COMMENTS RECEIVED
FOR
CALABASAS LANDFILL
REVISED WASTE DISCHARGE REQUIREMENTS
FOR
WASTE DISPOSAL, ASSESSMENT MONITORING PROGRAM, AND
CORRECTIVE ACTION PROGRAM

Comments on Tentative Order R4-2009-XXXX Waste Discharge Requirements Calabasas Landfill, Agoura Hills, CA (File No. 60-118)

**Minor Comments and Corrections on Tentative Order R4-2009-XXXX
Waste Discharge Requirements
Calabasas Landfill, Agoura Hills, CA (File No. 60-118)**

#6

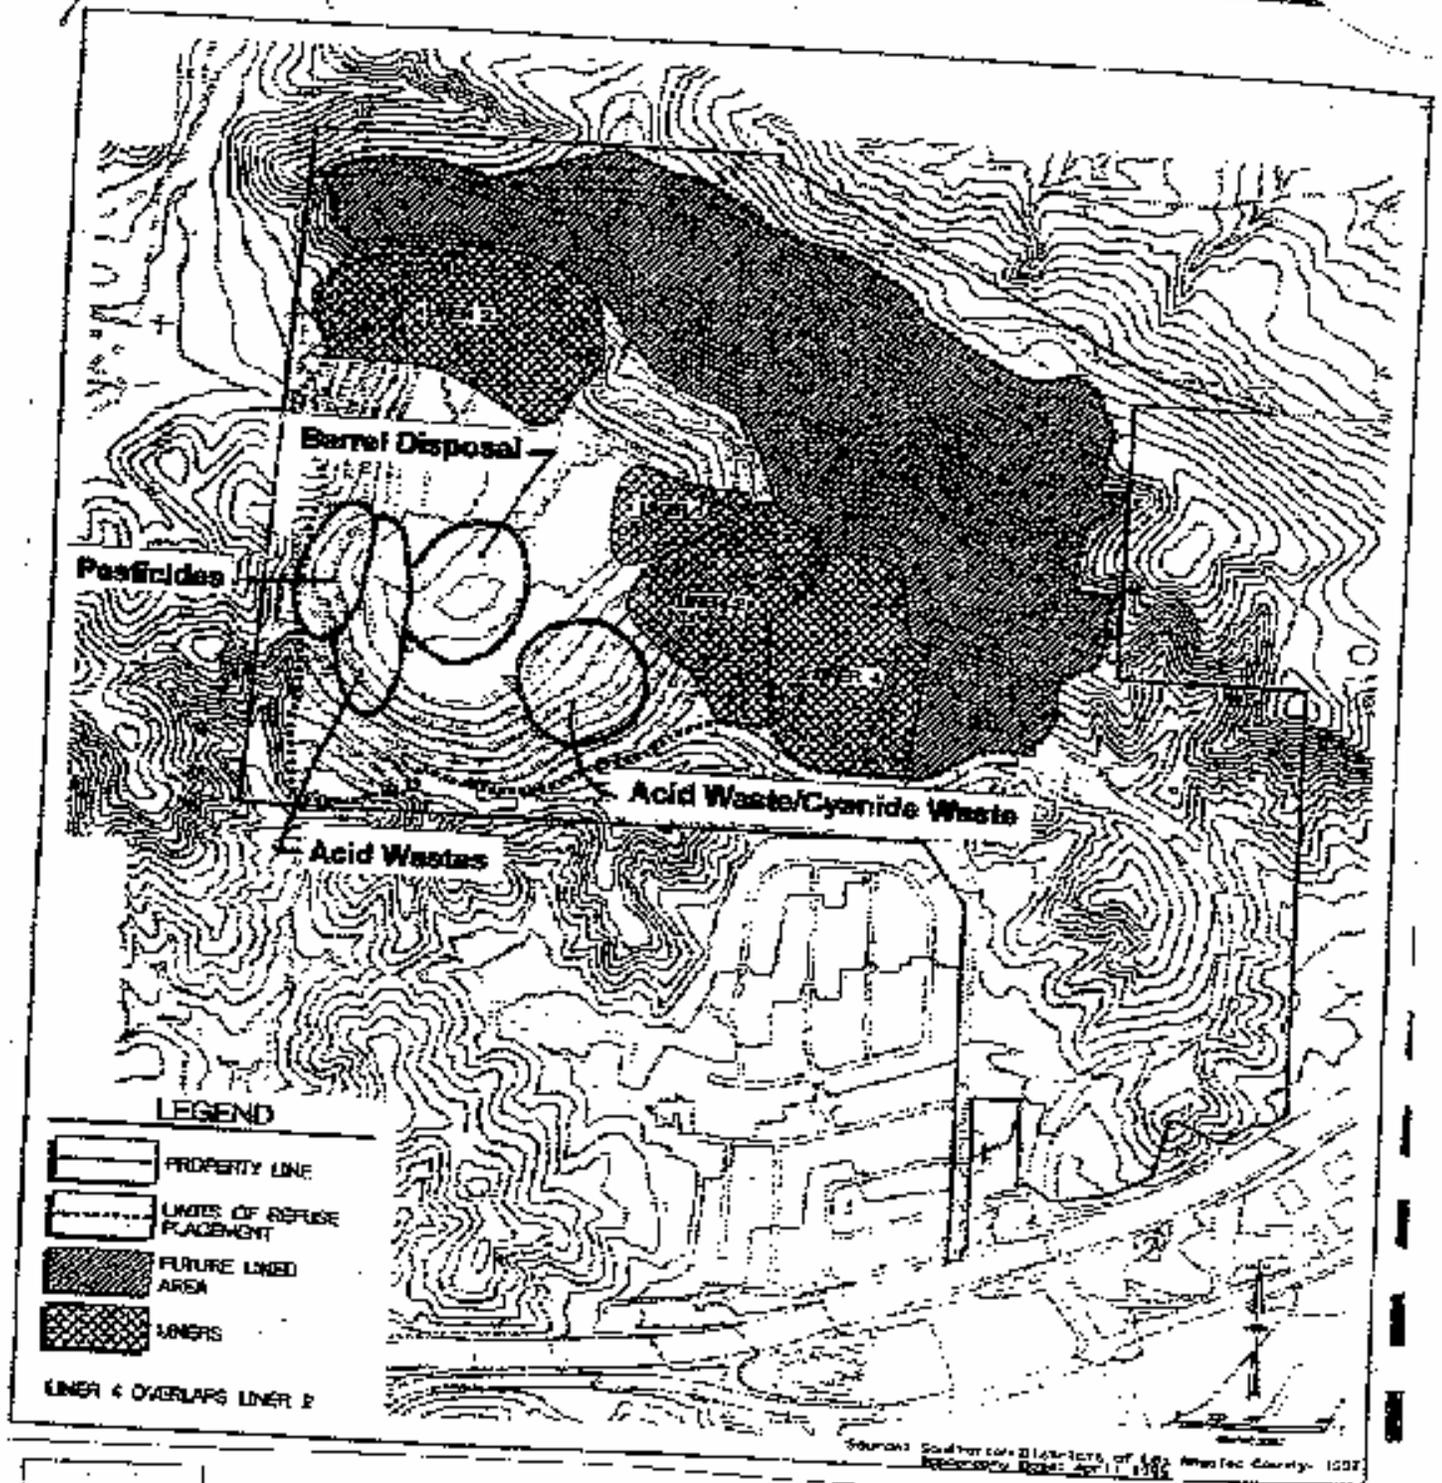
Pages 37 and 42. Replace Figure 5 with better maps. (Enc. #6) Figure 5 is not a good map for it is not clear where the unlined area of the landfill is. This is a very dangerous situation because the unlined area is the area, which received hundreds of tons of hazardous waste. (Review CD and Encs. #7) Disclosure is the key here and the public has the right to know of the huge potential of off site deep groundwater contamination because the hazardous area is not lined. The agencies should not allow any additional development within 1 mile of the Calabasas Landfill, which puts new human receptors in potential harm's way from soil gas migration from the deep groundwater in the water table.

Pages 37 and 42. Replace Figure 5 with better maps. (Enc. #6) figure 5 is not a good map for it is not clear where the unlined area of the landfill is. This is a very dangerous situation because the unlined area is the area, which received hundreds of tons of hazardous waste. (Review CD and Encs. #7) Disclosure is the key here and the public has the right to know of the huge potential of off site deep groundwater contamination because the hazardous area is not lined. The agencies should not allow any additional development within 1 mile of the Calabasas Landfill, which puts new human receptors in potential harm’s way from soil gas migration from the deep groundwater in the water table.
